E09 Image Solution Posted

Throughout the Manual

Figure 4-8

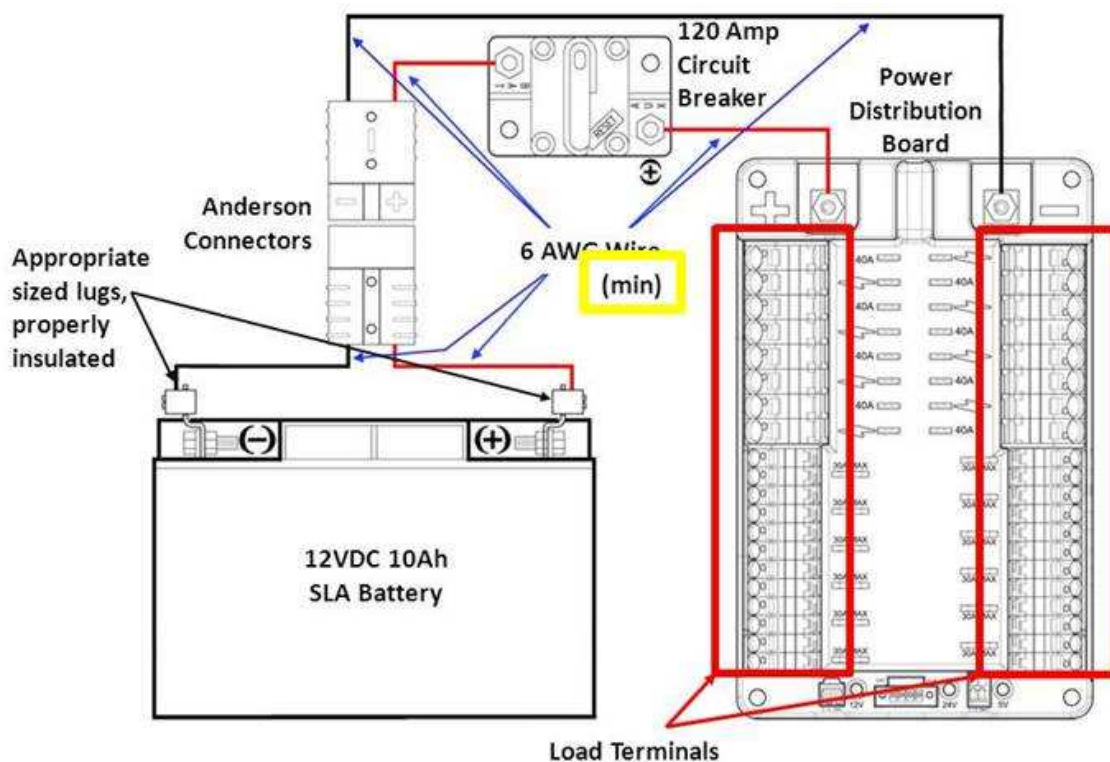
Figure 4-8 was revised to allow wire larger than 6AWG between the battery terminals and the Power Distribution Board terminals.

Figure 4-3

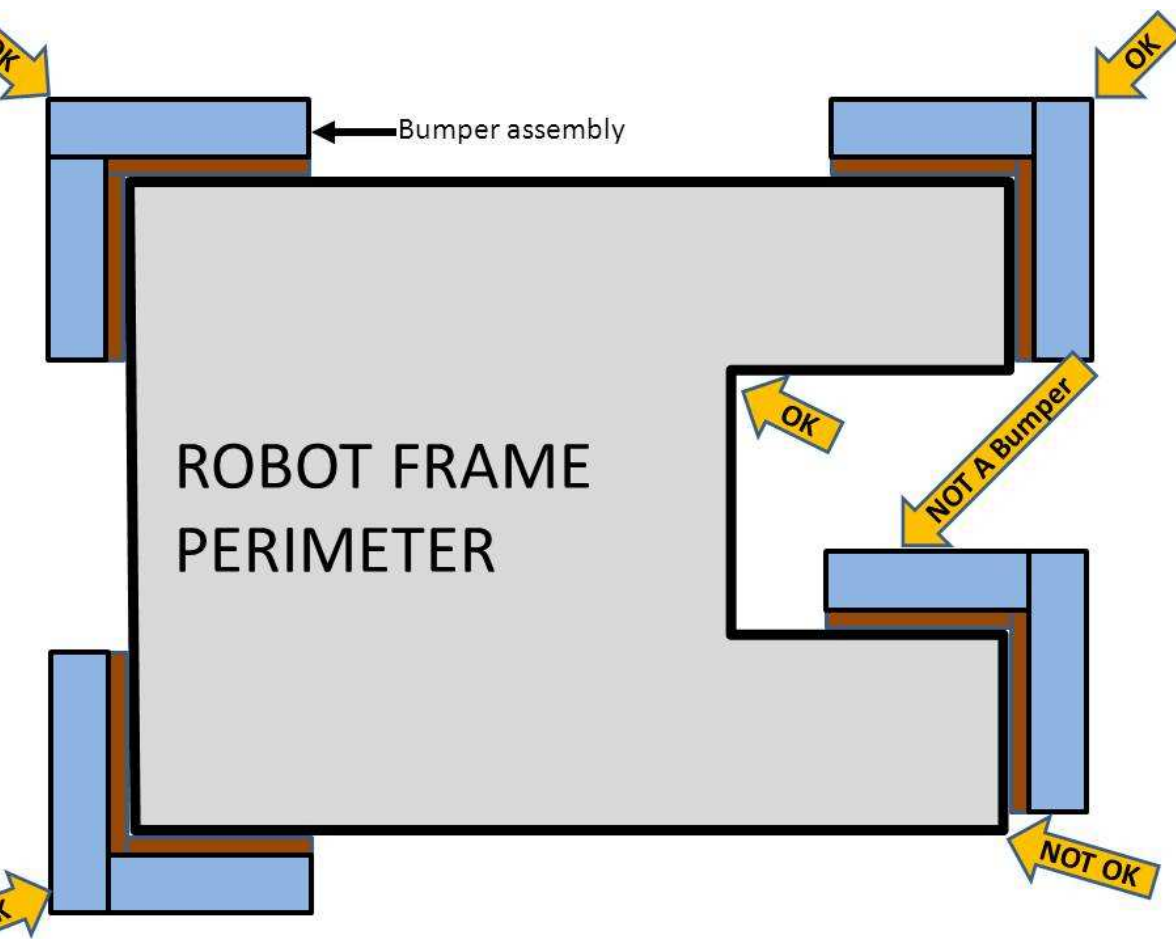
Figure 4-3 has been revised to clarify that example padding is legal, but not considered an official Bumper based on its placement.
